Board of Adjustment

Staff Report

CASE NUMBER: BA14-048 (PLN2014-00399)
STAFF PLANNER: Wahid Alam, AICP
LOCATION/ADDRESS: 1954 East Huber Street
COUNCIL DISTRICT: Council District 1
OWNER/ APPLICANT: John & Amanda Sohn

REQUEST: *Requesting a variance to allow a garage to encroach into the required side setback of an existing home in the RS-9 zoning district.*

BA14-048

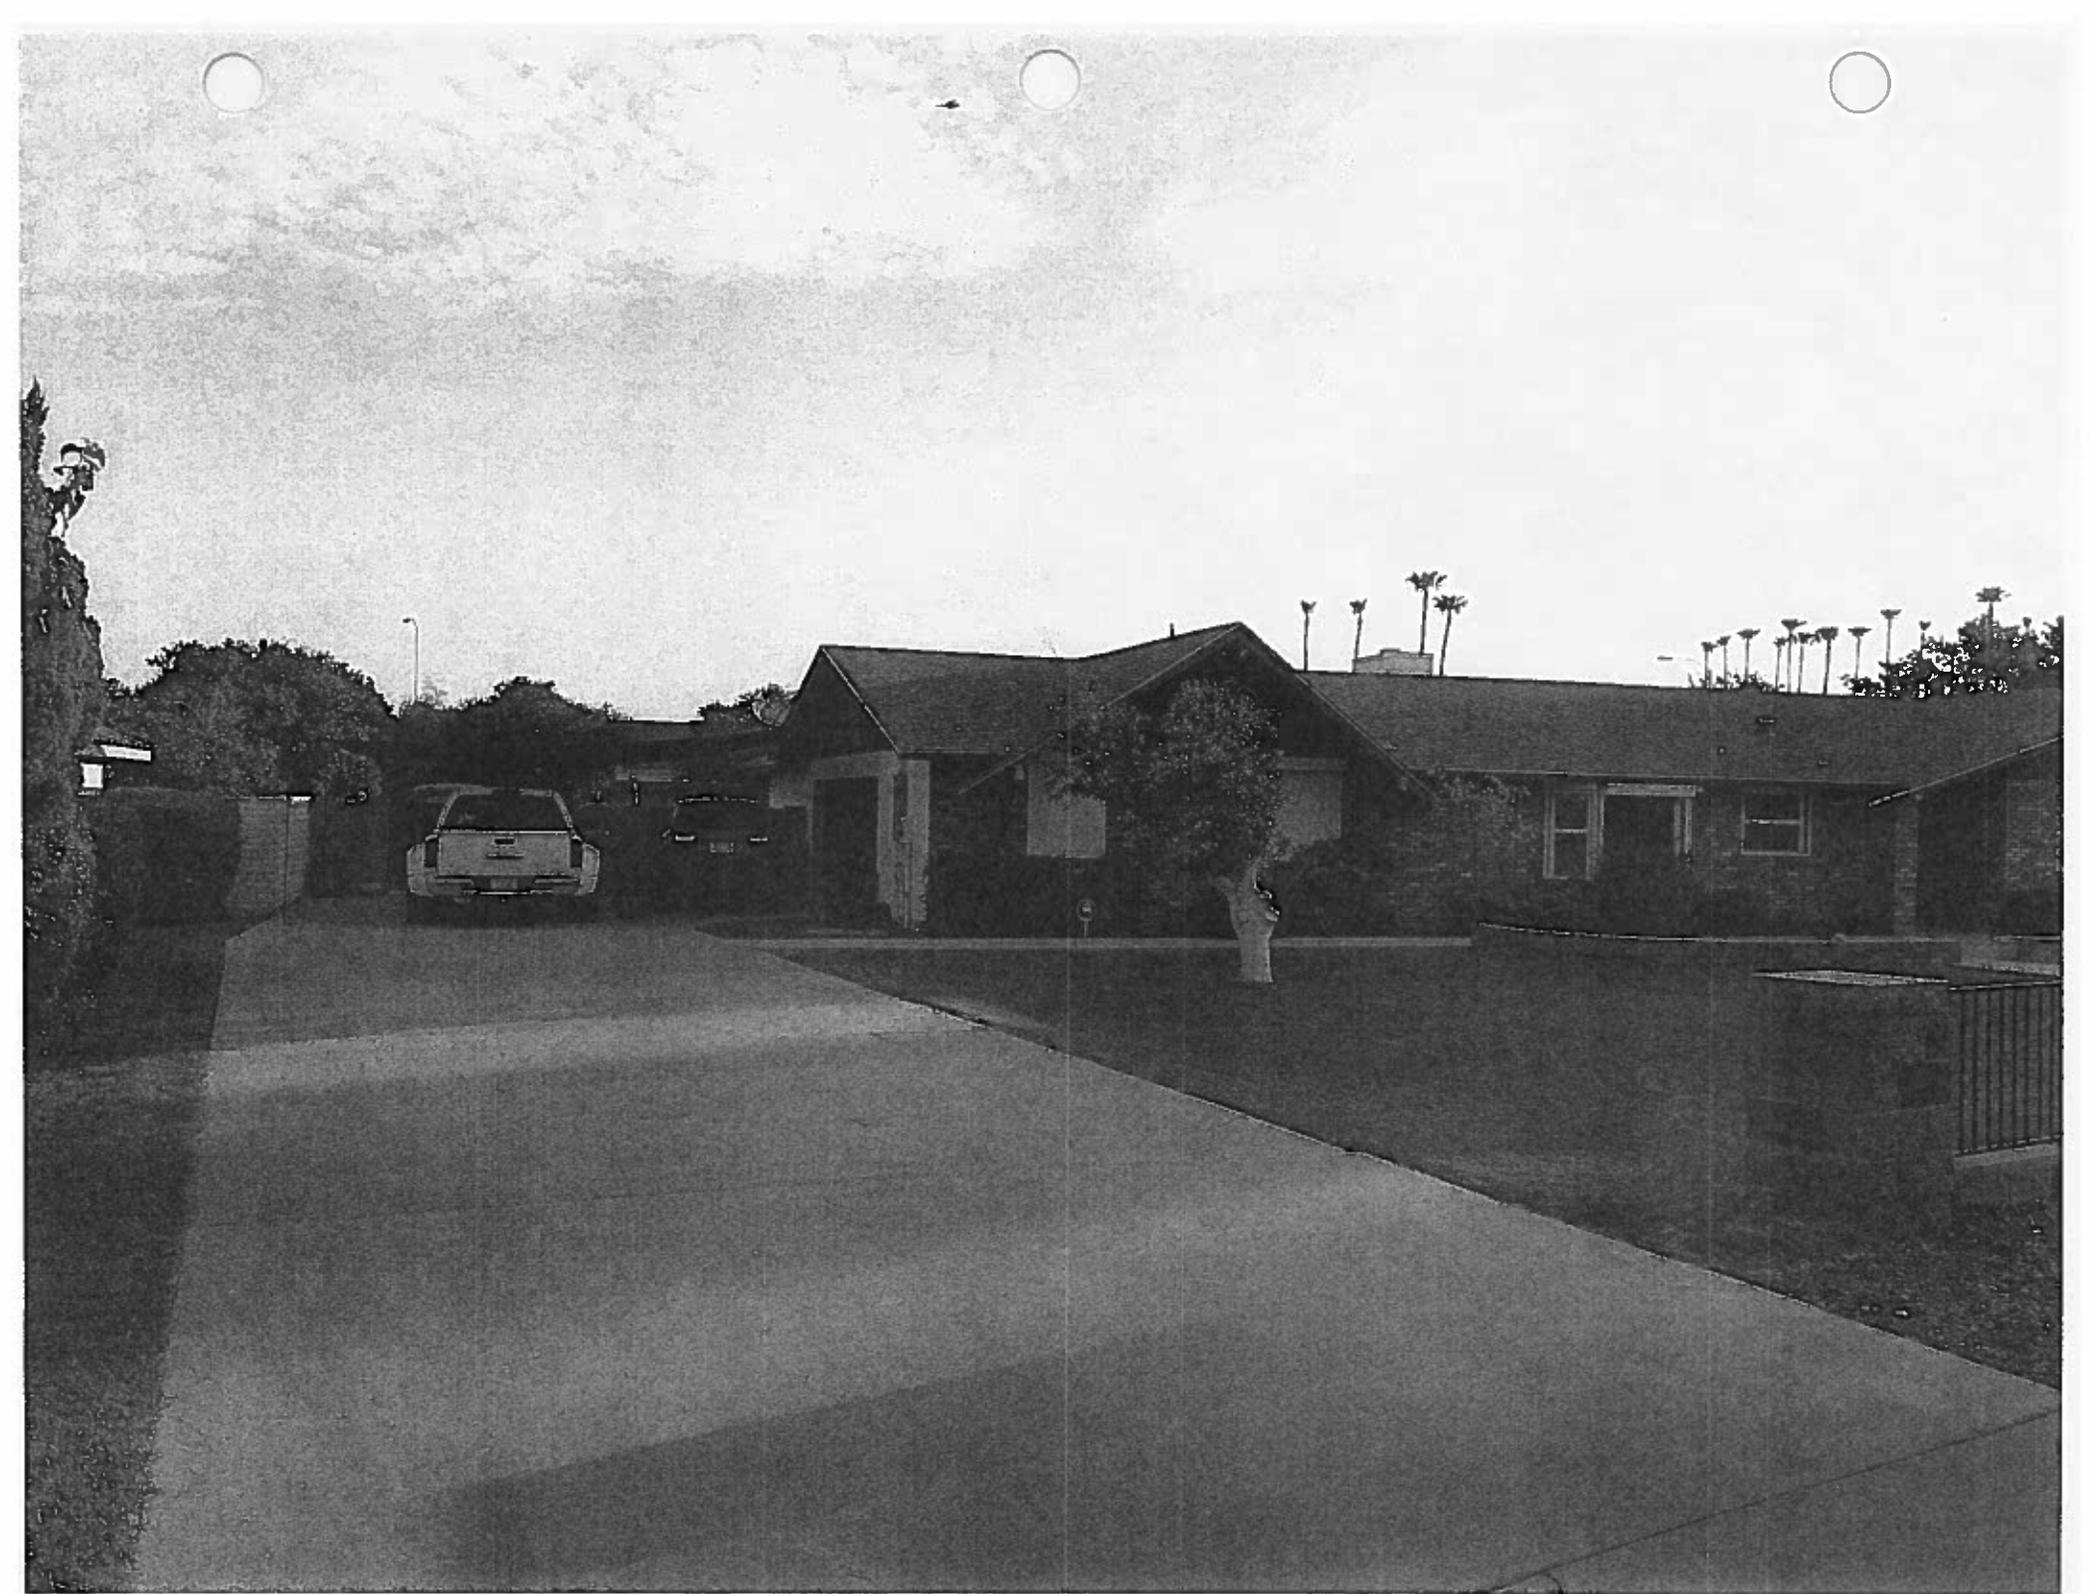
1. The garage addition is far too imposing as an addition closer to the street. The RV door and lack of articulation to the elevation is too flat and "Industrial" looking for 1/3 acre lots.

2. There is a lack of information in the letter received describing the conditions for the variance.....such as a Site Plan with dimensions although we did receive an aerial photo.

Until this applicant can show some sensitivity to an imposing addition, particularly on the corner lot abutting Gilbert Rd, we regret to not support this variance request.
